Project T10/1760-D

Revision 14
28 January 2008

Information technology - Serial Attached SCSI - 2 (SAS-2)

Summary of Comments on Serial Attached SCSI - 2 (SAS-2) Standard

Figure 10 — SAS Domain class diagram

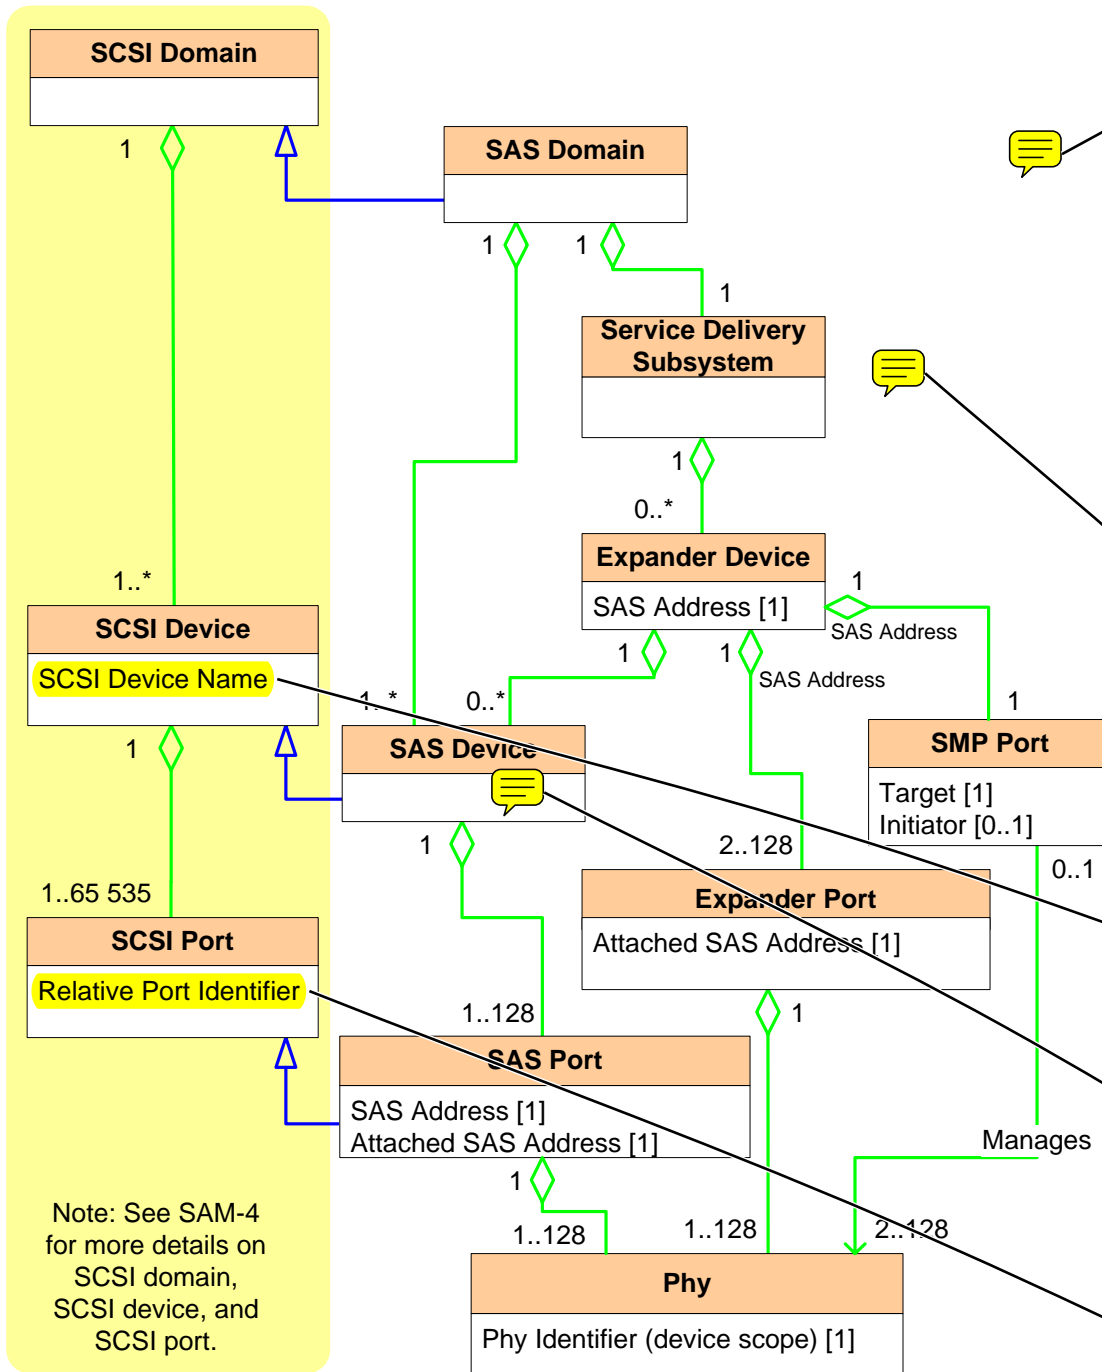
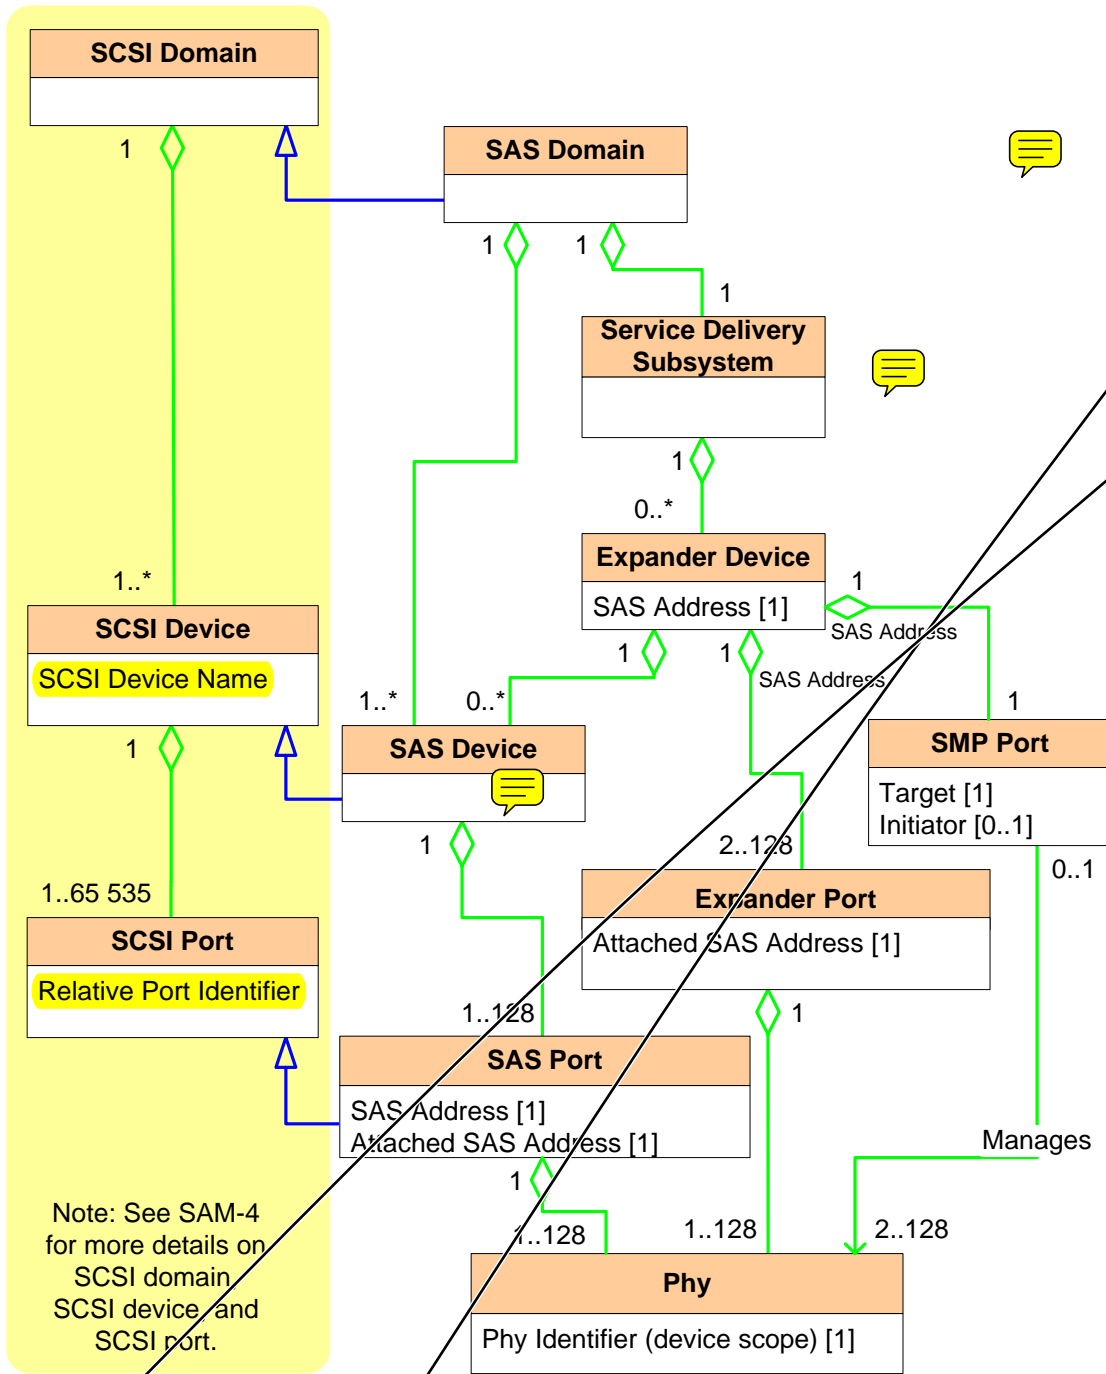
figure 10: changed 1..128 to 1..255

figure 10: changed 2.. to 2..255

Figure 16 — Port class diagram

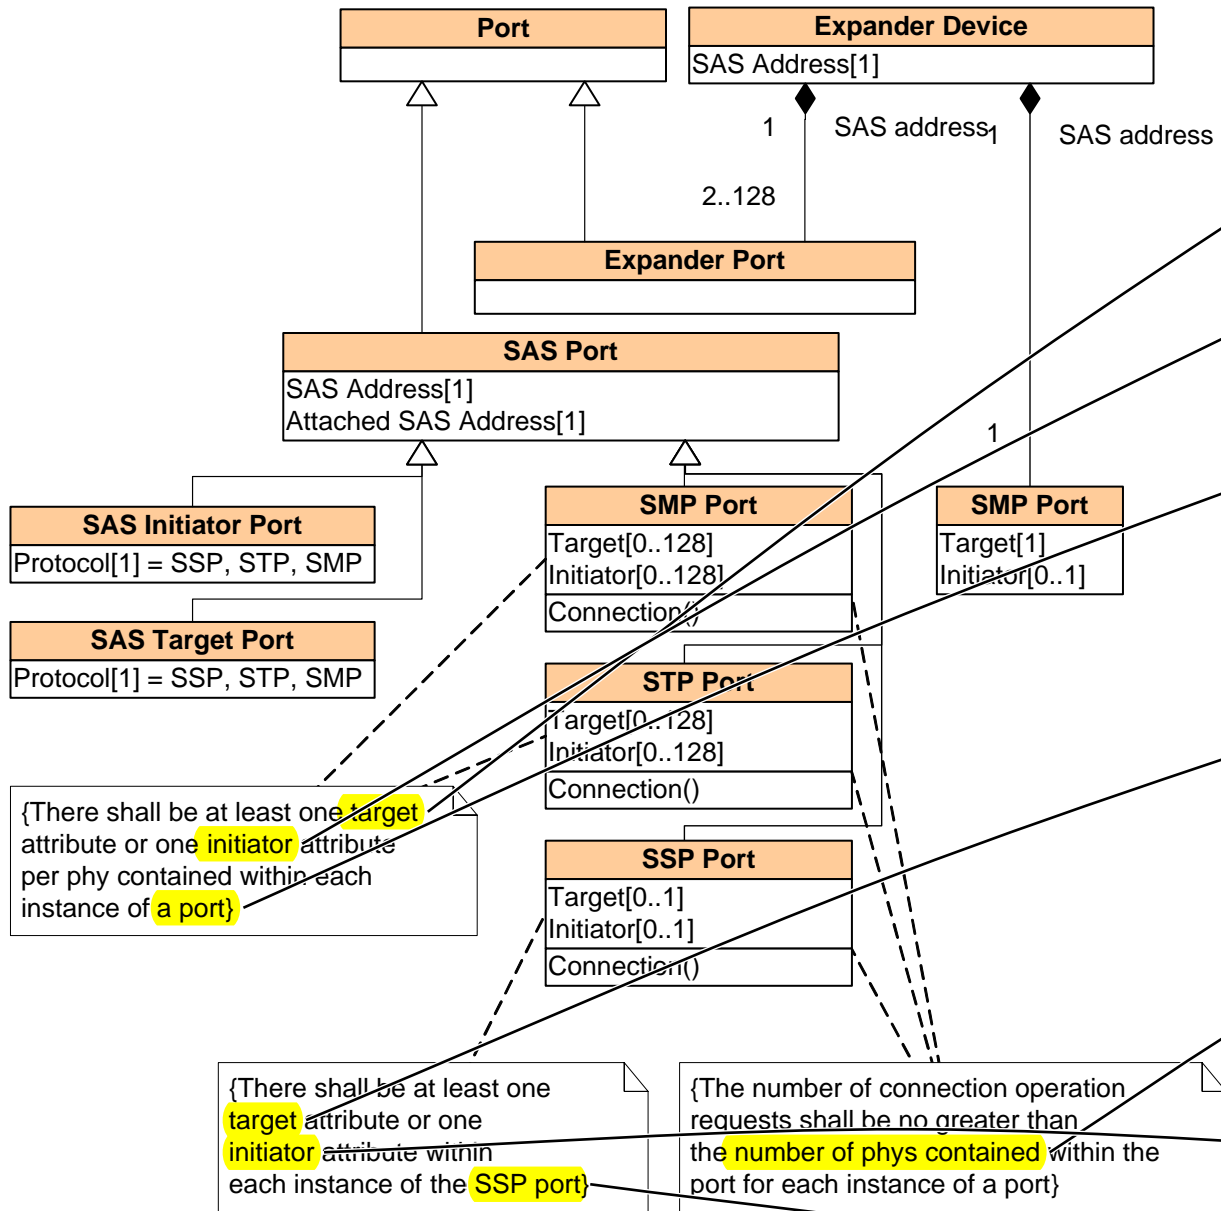
figure 16: changed [0..128] to [0..255] (zero to 255 possible phys)

figure 16: changed 2..128 to 2..255

Should be << detail is not shown. However, each port

Figure 31 — Transmit data path in a SAS phy

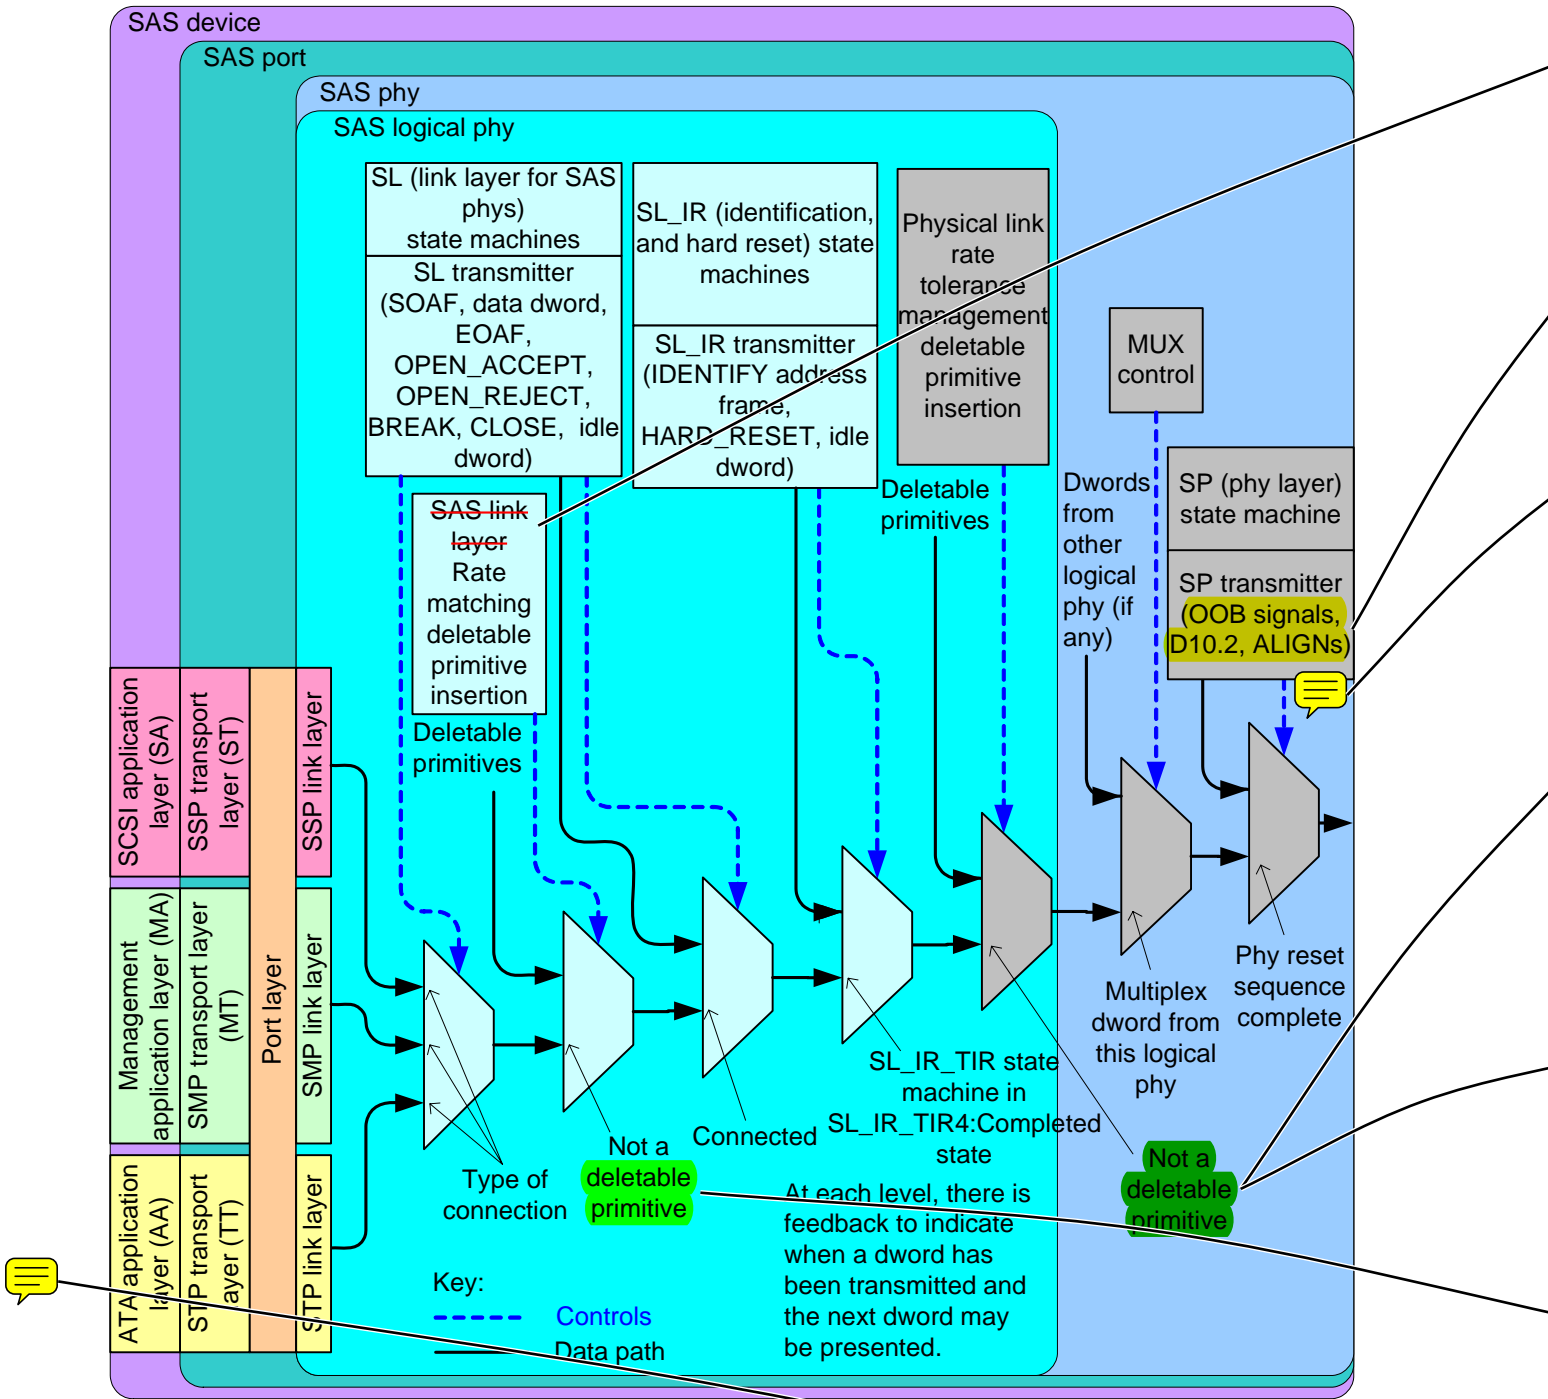
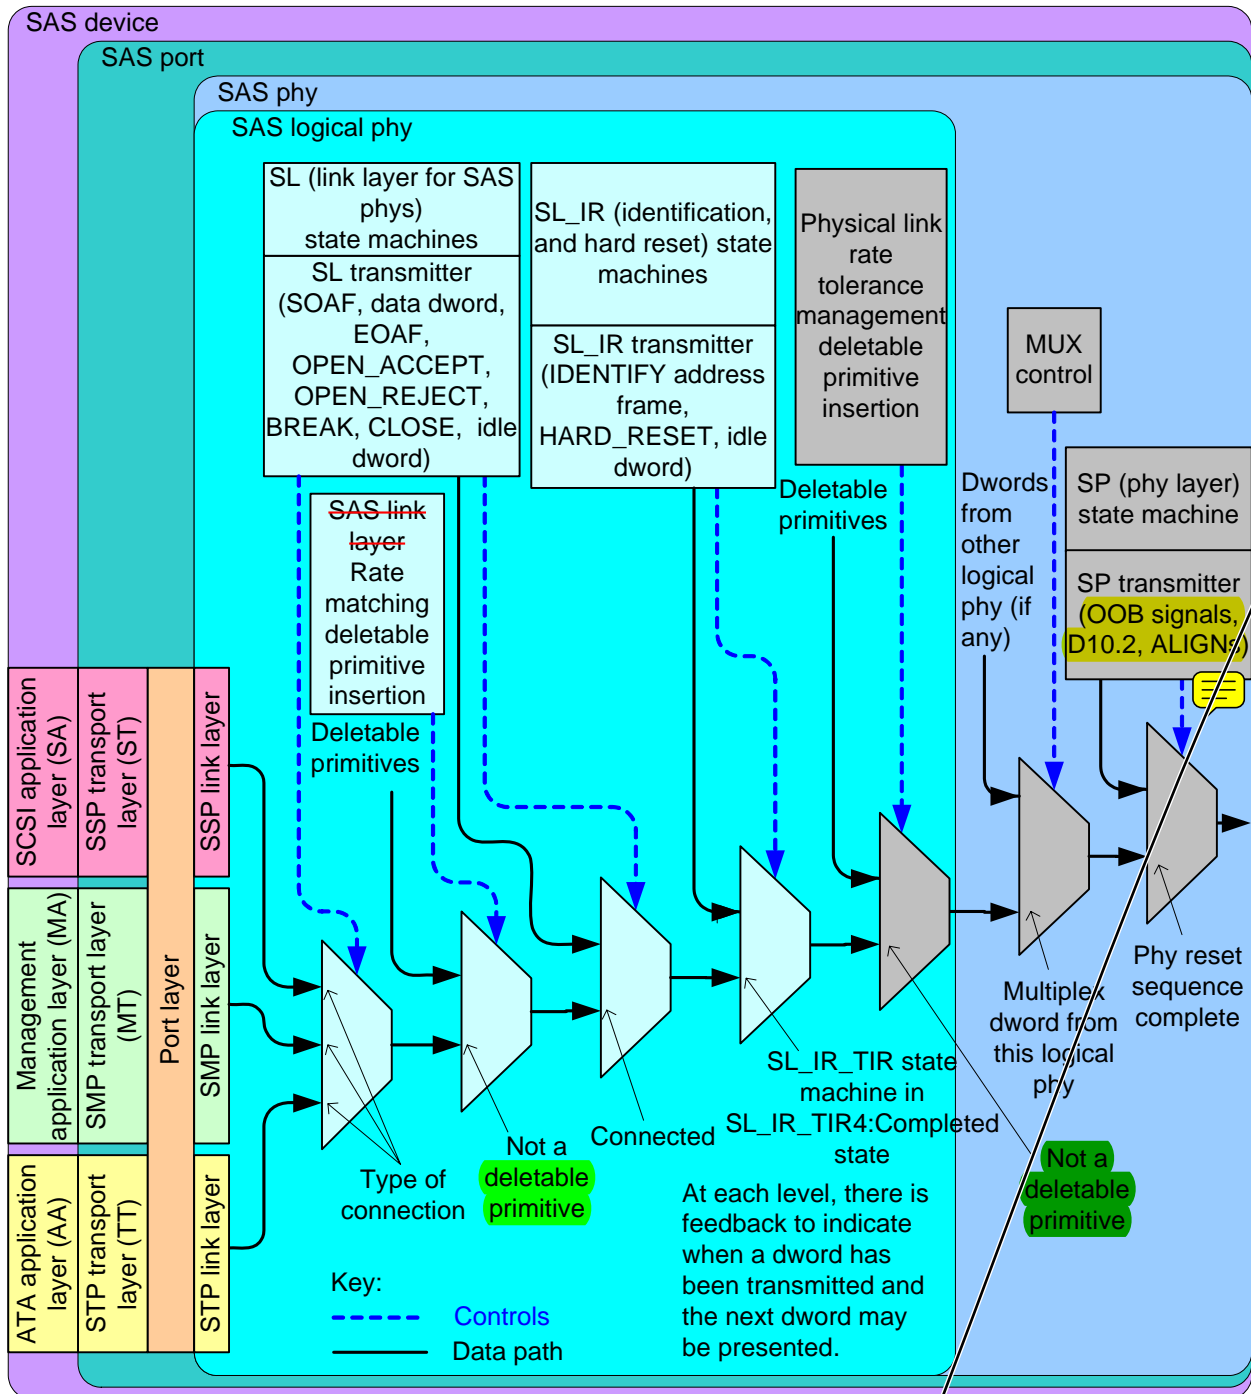
NOTE
s/b
Note

Figure 36 — Receive data path in a SAS phy

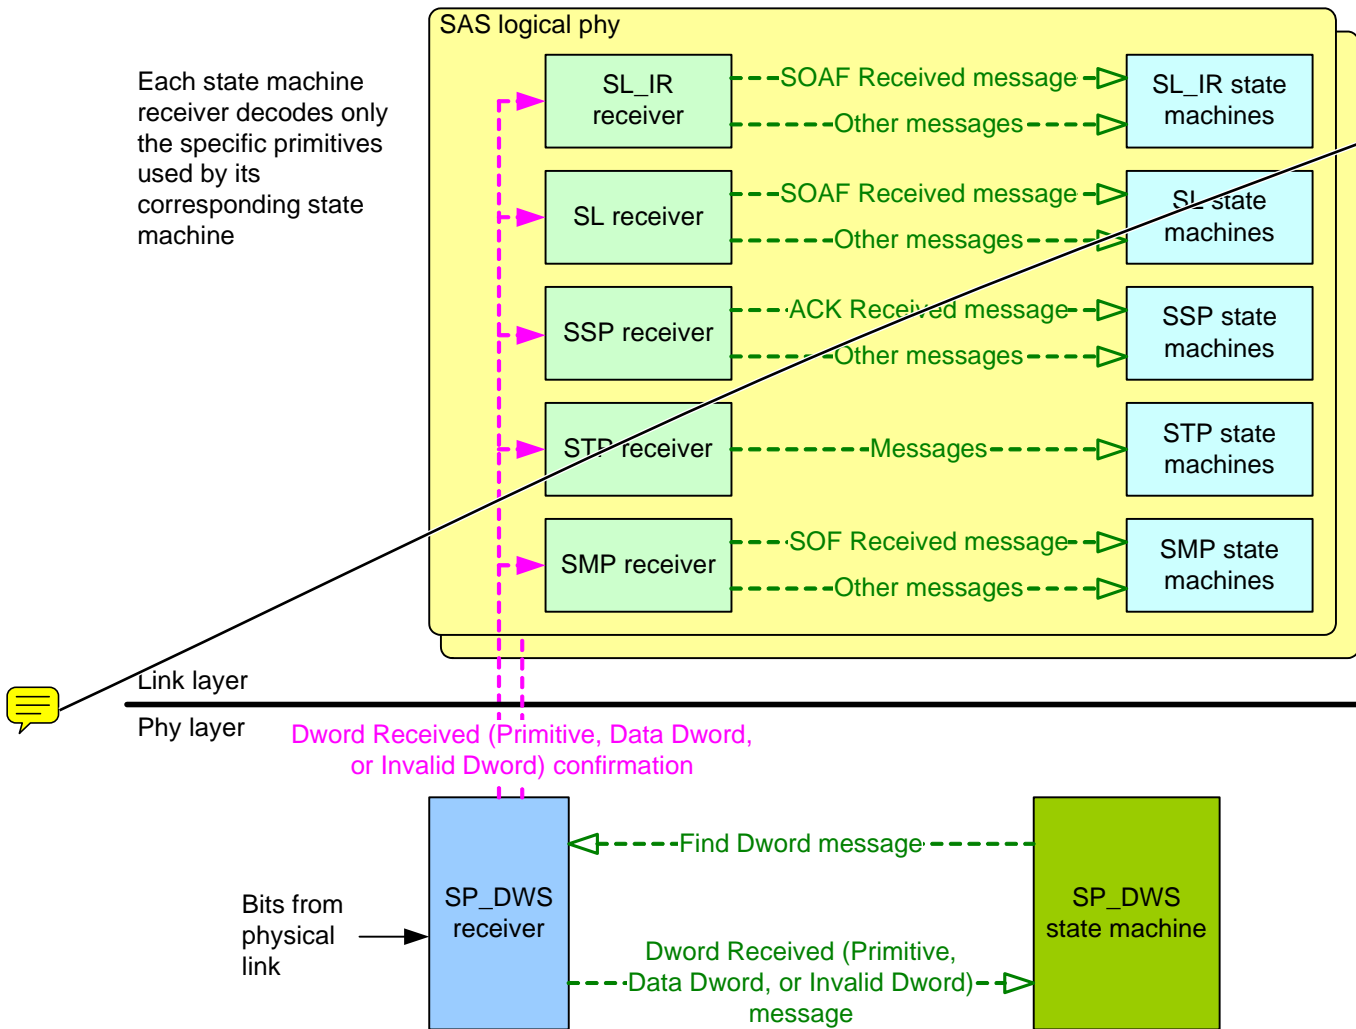
Add TRAIN pattern and TRAIN_DONE pattern to the list to match intc-mseidel comment on figure 31

See figure 168 in 7.3.1 for more information about the elasticity buffer, which is not shown in figure 36.

Figure 38 — State machines and SAS Device classes

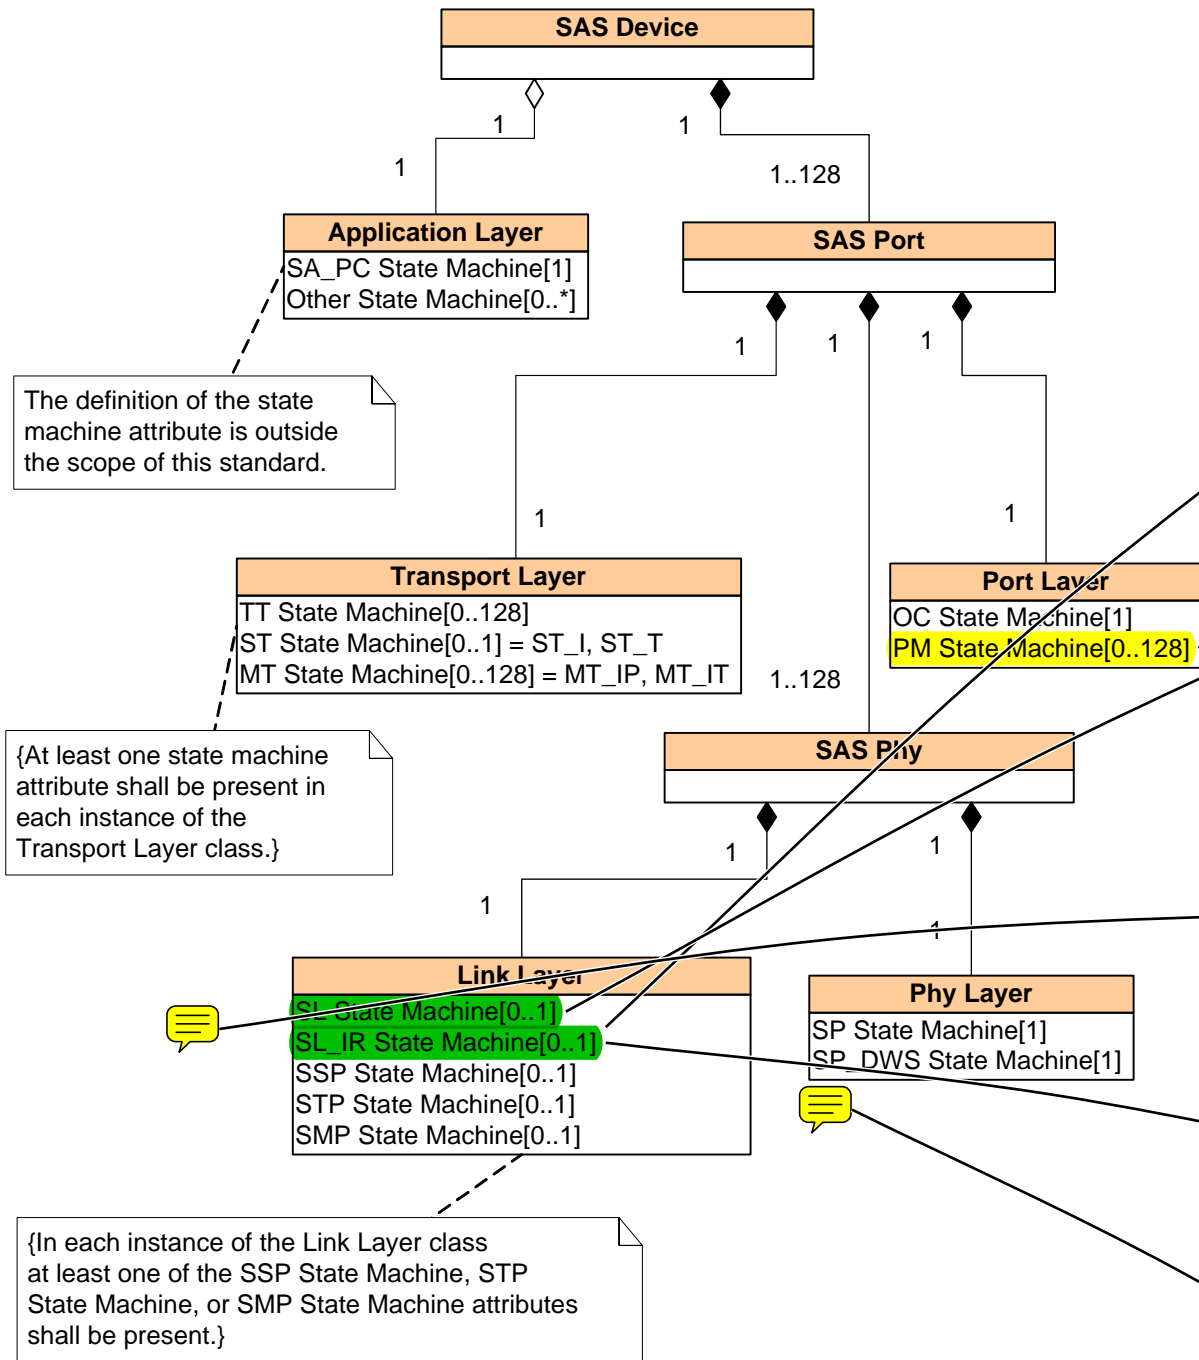
also figure 38: 0..128 to 0..255

also figure 38: 1..128 to 1..255
